SUBJECT: CERTIFICATION OF THE MINUTES OF THE ACRS SUBCOMMITTEE  
MEETING ON THE OYSTER CREEK GENERATING STATION LICENSE  
RENEWAL APPLICATION, JANUARY 18, 2007 - ROCKVILLE,  
MARYLAND

**ADVISORY COMMITTEE ON REACTOR SAFEGUARDS  
MINUTES OF ACRS PLANT LICENSE RENEWAL SUBCOMMITTEE MEETING  
OYSTER CREEK GENERATING STATION  
JANUARY 18, 2007  
ROCKVILLE, MARYLAND**

On January 18, 2007, the Plant License Renewal Subcommittee held a meeting in Room T2B3, 11545 Rockville Pike, Rockville, Maryland, to review the License Renewal Application (LRA) for the Oyster Creek Generating Station (OCGS) and the associated Safety Evaluation Report (SER) with Open Items.

# Drywell Model – Elevations and Regions

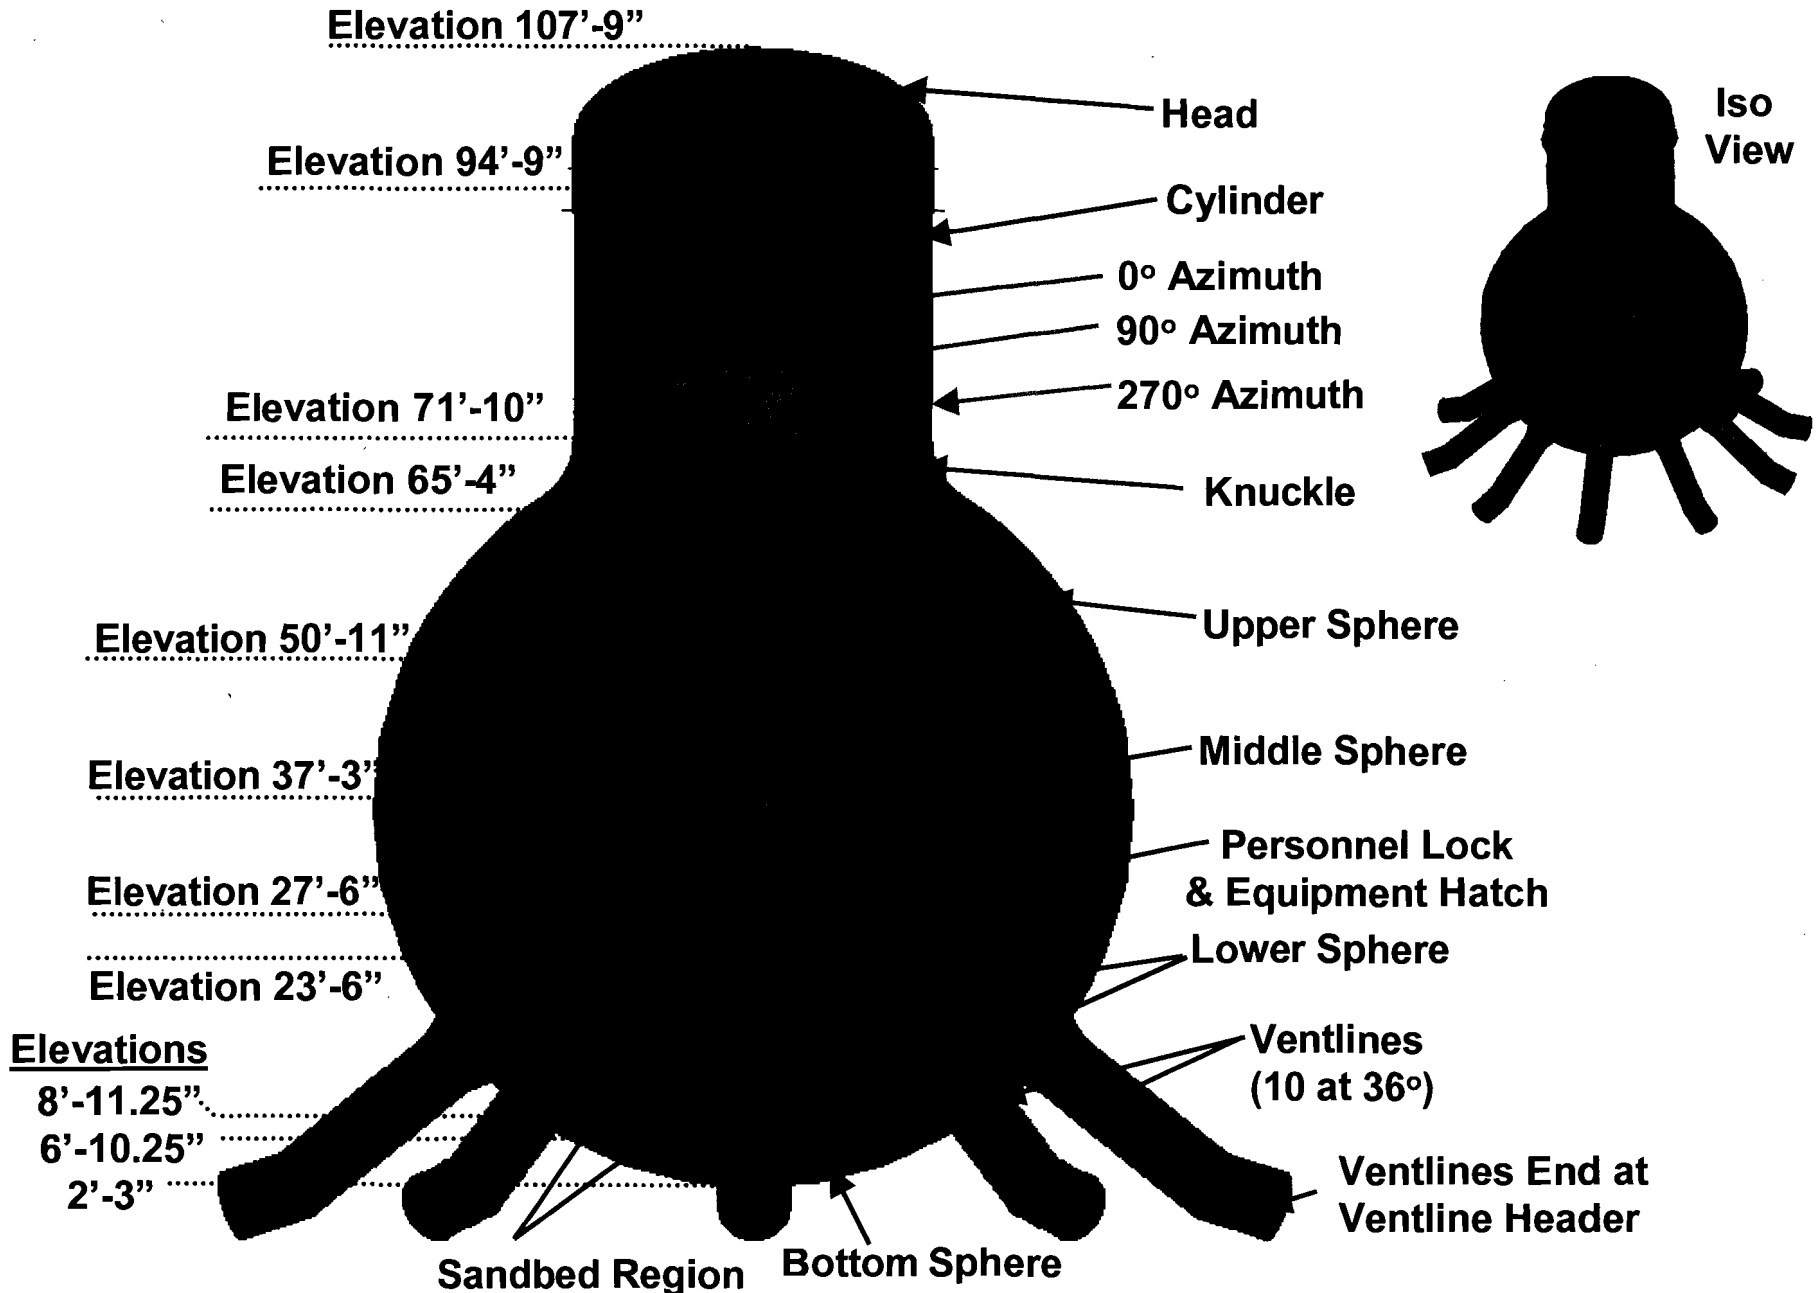
Dr. Bonaca's comments: Dr. Bonaca felt the presentation provided an assertion that the corrosion has been stopped and that the drywell can operate until 2029. He would like to hear the monitoring program discussed in more detail at the full committee meeting. He would like to see a more aggressive short term inspection program but also thinks waiting for ten years to do the inspections again is too long a time period to wait. He raised the issue of controlling sources of water several times. He questioned whether the applicant has done as much as they can to control the sources of water to ensure there is no further accumulation in the drywell. He also questioned whether there was any corrosion taking place behind the epoxy and if the applicant was going to perform UT inspections to identify that there may be some weakness behind the epoxy. Lastly, he questioned how large an area of thinning could be tolerated on the drywell shell and still meet its design.

# Minimum Uniform Sandbed Thickness

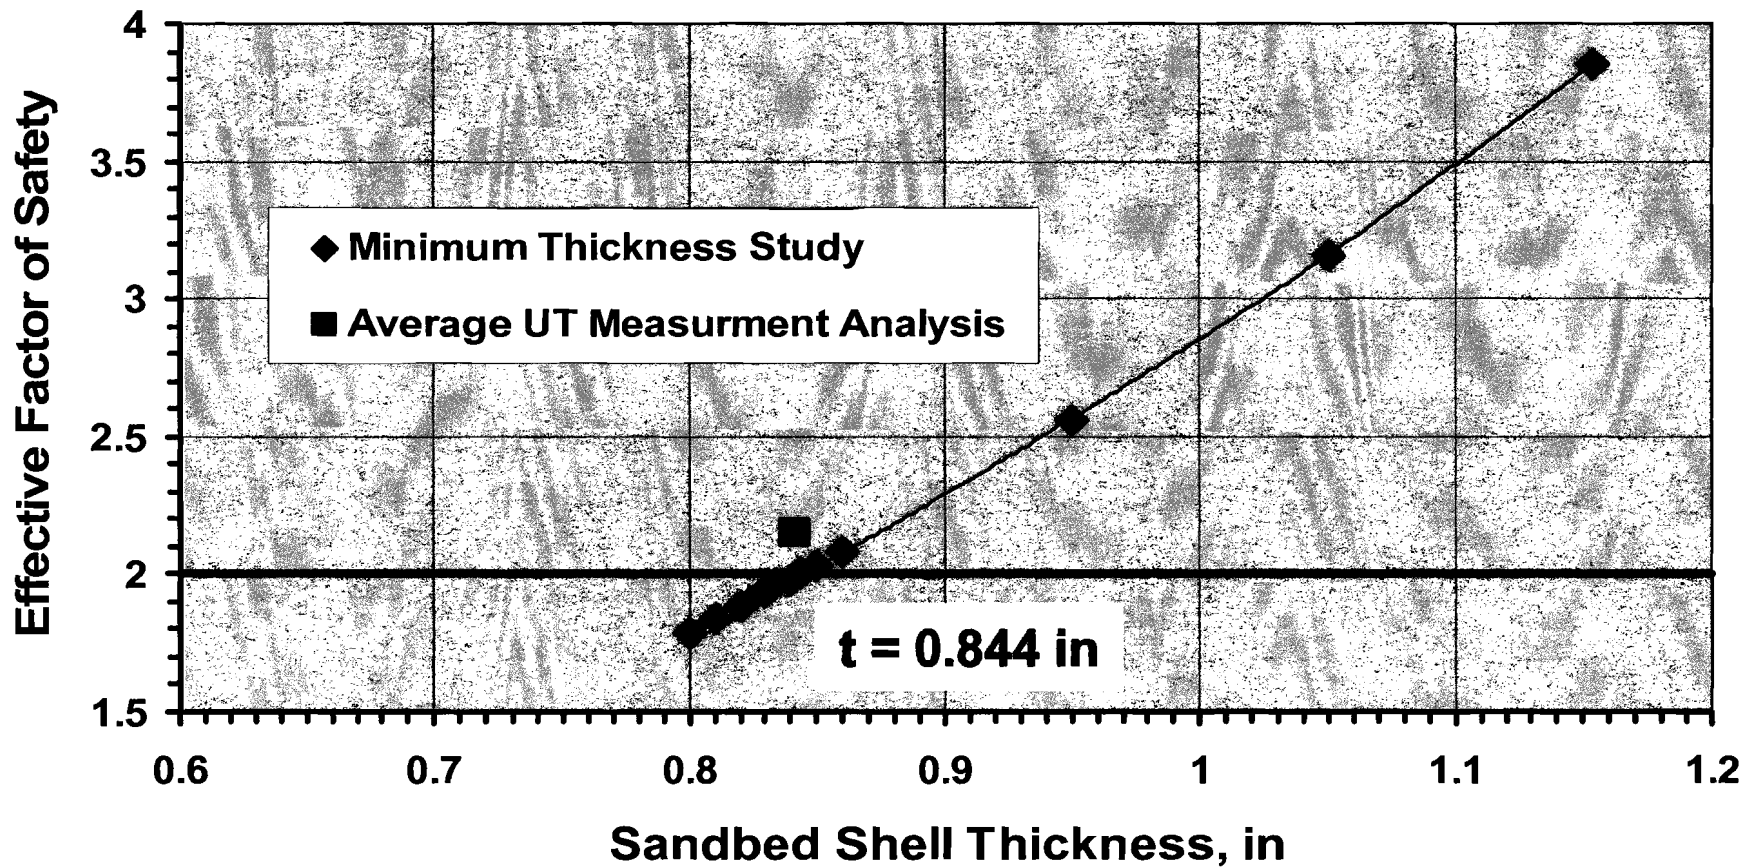
Dr. Wallis' comments: Dr. Wallis questioned how good the buckling analysis had to be, how close to the limit is too close? He felt the buckling analysis was the most important issue and he wasn't sure if it was adequate.

- **OI 4.7.2-1.3:** Buckling Analysis: Question on the appropriateness of certain technical assumptions in AmerGen's analysis of the potential for "buckling" of the drywell shell

3. In RAI 4.7.2-1 dated March 10, 2006, the staff requested that the applicant provide the following information: A summary of the factors considered in establishing the minimum required drywell thickness. On further evaluation of the applicant's information, the staff concluded that the stability evaluation was consistent with the guidelines of ASME Code Case N-284-1. The staff's concern about use of the same section strength across the corroded section of the shell is addressed by Code Case N-284-1, which uses conservative assumptions to determine shell capacity reduction factors (i.e., assumption of imperfection limit indicated by parameter "e/t" to be 1.0 in the code case) expected to compensate reasonably for such use of the same section strength. In addition, the applicant conservatively assumed the local corroded thickness for the entire drywell shell region and demonstrated that the code-allowable stresses were satisfied consistently with the guidelines of the code case. Thus, this analysis adds a margin of safety for the drywell stability evaluation. On this basis, the staff believes that the stability evaluation method is adequate and acceptable, and the staff's concern is resolved. Open Item 4.7.2-1.3 is closed.
